# Access Compliance Report

## Public Rights-of-Way

### (Curb Ramps)

Intersection ID: 11016	Main Street: AMBASSADOR_ST	Cross Street: TUCKASEEGEE_RD	Location:	N
ADA ID: 2430A607DBC4	Ramp Type: Perp	Initial Pass/Fail: Fail	Overall Compliance: No	Severity Score: 25

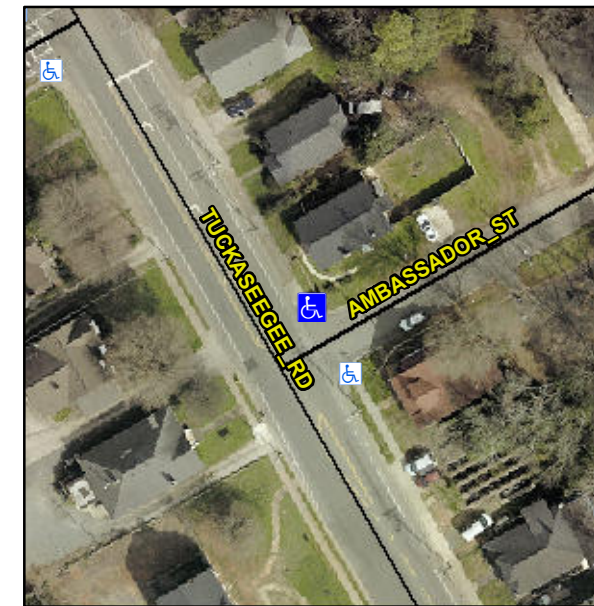
**Not Found, R304.5.3**

Compliance	Description	Data	Compliance	Description	Data
N/A	Ramp Length (in)	74.0	Yes	Ramp Slope (%)	5.8
Yes	Ramp Width (in)	48.0	No	Ramp XSlope (%)	17.6
N/A	Flare Type LT	N/A	N/A	Flare Type RT	N/A
N/A	Flare Slope LT (%)	N/A	N/A	Flare Slope RT (%)	N/A
N/A	Flare Traversable LT?	N/A	N/A	Flare Traversable RT?	N/A
N/A	Landing Length (in)	N/A	N/A	DWS Provided?	N/A
N/A	Landing Width (in)	N/A	N/A	DWS Contrast?	N/A
N/A	Landing Slope (%)	N/A	N/A	DWS Length (in)	N/A
N/A	Landing X Slope (%)	N/A	N/A	DWS Full Width?	N/A
N/A	Landing Curb? (Y/N)	N/A	N/A	DWS Offset (in)	N/A
N/A	Shared Landing?	N/A			
N/A	Gutter Ponding?	N/A	N/A	Gutter Slope (%)	N/A
N/A	Gutter Lip Ht (in)	N/A	N/A	Gutter X Slope (%)	N/A
N/A	Painted X Walk1?	No	N/A	Painted X Walk2?	N/A
	X Walk 1 Direction	To S		X Walk 2 Direction	N/A
N/A	X Walk 1 Width (in)	N/A	N/A	X Walk 2 Width (in)	N/A
	X Walk 1 Slope (%)	2.8		X Walk 2 Slope (%)	N/A
	X Walk 1 X Slope (%)	18.8		X Walk 2 X Slope (%)	N/A

**Remove & Replace Entire Ramp.**
